**SUBJECT: TURKEY POINT NUCLEAR GENERATING UNIT NOS. 3 AND 4 - ISSUANCE
OF AMENDMENTS REGARDING TECHNICAL SPECIFICATION FIGURE FOR
THE BORIC ACID TANK MINIMUM VOLUME (CAC NOS. MF6148
AND MF6149)**

The amendments revise TS Figure 3.1-2, "Boric Acid Tank Minimum Volume," to reflect corrections to an instrument uncertainty calculation.

SAFETY EVALUATION BY THE OFFICE OF NUCLEAR REACTOR REGULATION FOR
AMENDMENT NO. 270 TO RENEWED FACILITY OPERATING LICENSE NO. DPR-31 AND
AMENDMENT NO. 265 TO RENEWED FACILITY OPERATING LICENSE NO. DPR-41
FLORIDA POWER & LIGHT COMPANY
TURKEY POINT NUCLEAR GENERATING UNIT NOS. 3 AND 4
DOCKET NOS. 50-250 AND 50-251

Figure 3.1-2
BORIC ACID TANK MINIMUM VOLUME (1)
Modes 1, 2, 3 and 4

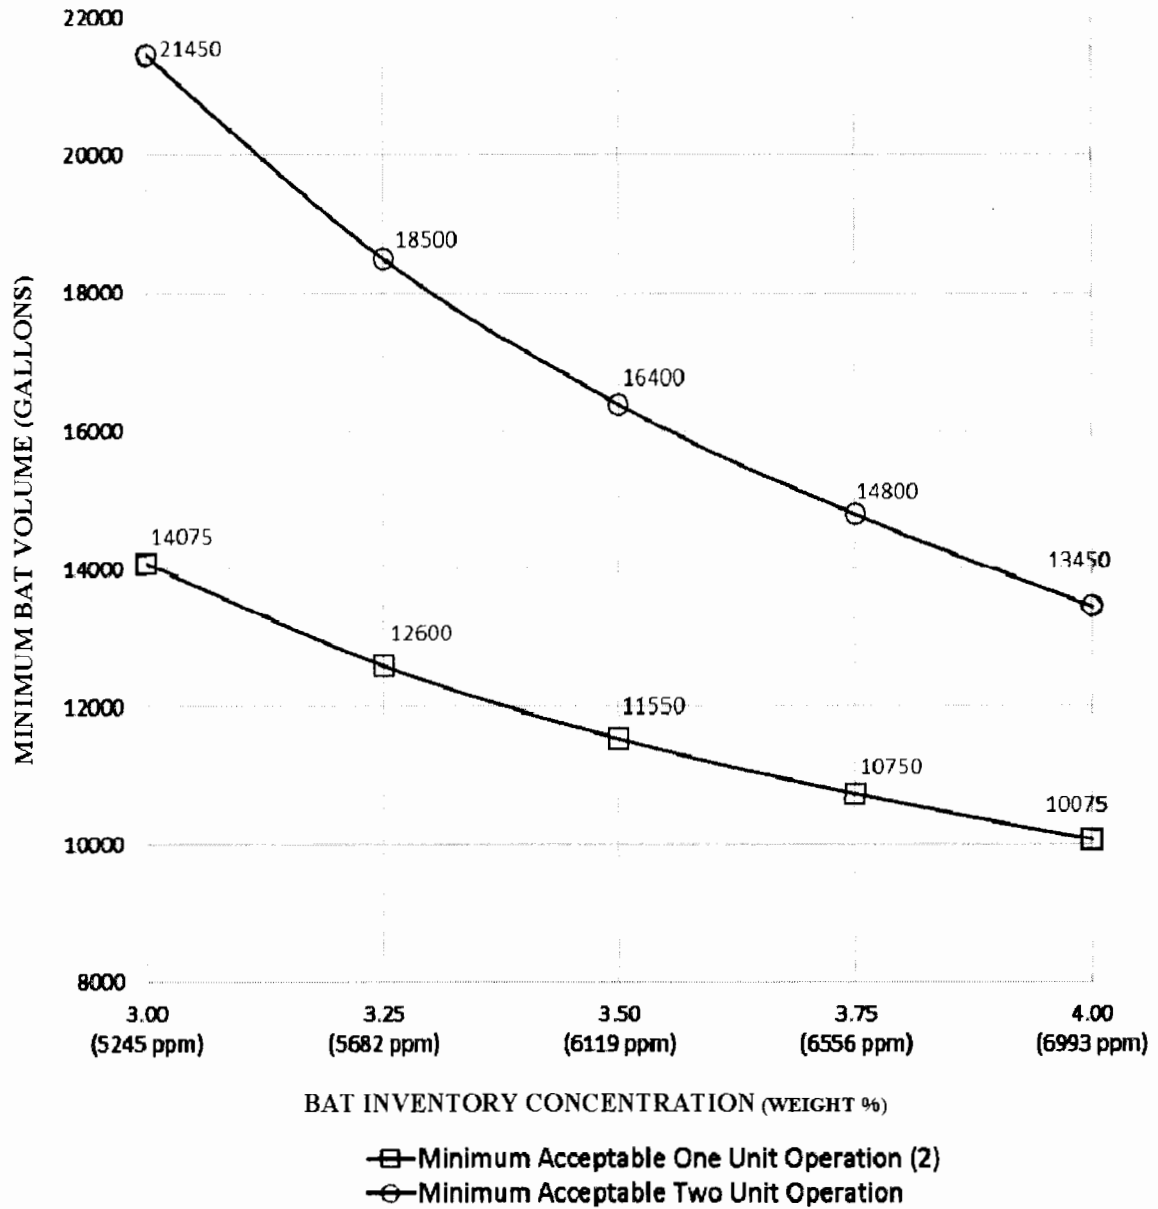
The licensee proposed to revise TS Figure 3.1-2 to reflect corrections to an instrument uncertainty calculation and to correct nonconservative TS requirements. The curves in TS Figure 3.1-2 incorporate an instrument uncertainty of 600 gallons for one-unit operation and 1200 gallons for two-unit operation. These values were approved in Amendment Nos. 249 and 245, which the NRC issued for Unit 3 and 4, respectively, on June 15, 2012.³ However, the licensee identified two issues in its calculation of the minimum acceptable BAT volume for a given boron concentration.

In its application dated April 16, 2015, the licensee stated that the instrument uncertainty of 600 gallons was erroneously doubled to 1200 gallons and included in the BAT minimum volume curve for two-unit operation. The licensee stated that the BATs are common equipment that serves both units and, therefore, the instrument uncertainty for two-unit operation should not have been counted twice when establishing the minimum acceptable BAT volume curve.

In its application dated April 16, 2015, the licensee also indicated that when calculating the total loop uncertainty (TLU) for the BAT instrumentation that monitors BAT level, the conversion of the TLU into equivalent tank volume uncertainty (in gallons) was incorrectly calculated based on the volume of a single BAT. The calculation should have considered the volume of a common tank comprised of three BATs cross-tied together. Therefore, the calculated TLU was underestimated, which resulted in the instrumentation uncertainty increasing from 600 gallons to

900 gallons. This issue impacts both the one-unit operation curve and the two-unit operation curve in TS Figure 3.1-2.

In summary, both curves in TS Figure 3.1-2 should reflect an instrument uncertainty of 900 gallons. The licensee proposed to revise Figure 3.1-2 by shifting the one-unit operation curve up by 300 gallons, which would correct a nonconservative TS, and the two-unit operation curve down by 300 gallons in order to reflect the correct instrument uncertainty values for both curves.

The issues found by the licensee in the instrument uncertainty impacts both the uncertainty for one-unit and two-unit operation. The uncertainty included in the current TS Figure 3.1-2 is 600 gallons for one-unit operation and 1200 gallons for two-unit operation. The corrected uncertainty is 900 gallons for both one- and two-unit operation. This is an increase in uncertainty for one-unit operation and a decrease for two-unit operation. These issues could potentially challenge the ability to achieve cold shutdown conditions without letdown with the most reactive RCCA not inserted, particularly for one-unit operation. This is because the actual minimum volume in the BAT (i.e., the instrument indicated volume minus the uncertainty) could be less than previously assumed, which is nonconservative. As discussed in the licensee's application dated April 16, 2015, the licensee established administrative controls to assure that the minimum acceptable BAT volume for one-unit operation is within the corrected values until these amendments are granted and implemented.

The licensee incorporated the corrected uncertainty values by adjusting the nominal curves on TS Figure 3.1-2. The nominal curves show the requirements for the values observed from the tanks' level gauges. While both the proposed nominal curves and uncertainty values have changed from those values currently in the TSs, the difference between the nominal curves and uncertainty values is the same for both the proposed and current TSs. These amendments do not change the minimum volume needed to satisfy design basis accident analyses.

Because the current BAT volume requirements in TS Figure 3.1-2 for one-unit operation assumes a TLU value of 600 gallons, the licensee proposed adding 300 gallons to those values to reflect the 900-gallon TLU value. Because the current BAT volume requirements in TS Figure 3.1-2 for two-unit operation assumes a TLU value of 1200 gallons, the licensee proposed subtracting 300 gallons from those values to reflect the 900-gallon TLU value.

Because the nominal minus uncertainty values assumed in the evaluations to achieve cold shutdown are unchanged in the proposed amendment, Turkey Point GDC 30, which requires the reactivity control system be capable of making and holding the core subcritical under any conditions with appropriate margin for contingencies, and the 10 CFR 50.36 requirement to have LCOs that are the lowest functional capability of equipment to perform their safety operation, continue to be met with the proposed amendments. The staff also determined that the licensee's calculation methodology and results are adequate and consistent with safety analysis assumptions and NRC guidance. Thus, the staff finds that the proposed TS change will not adversely affect plant operation, impact the performance of safety-related equipment, or otherwise compromise the public health and safety. The staff concludes that the proposed changes to TS Figure 3.1-2 are acceptable.
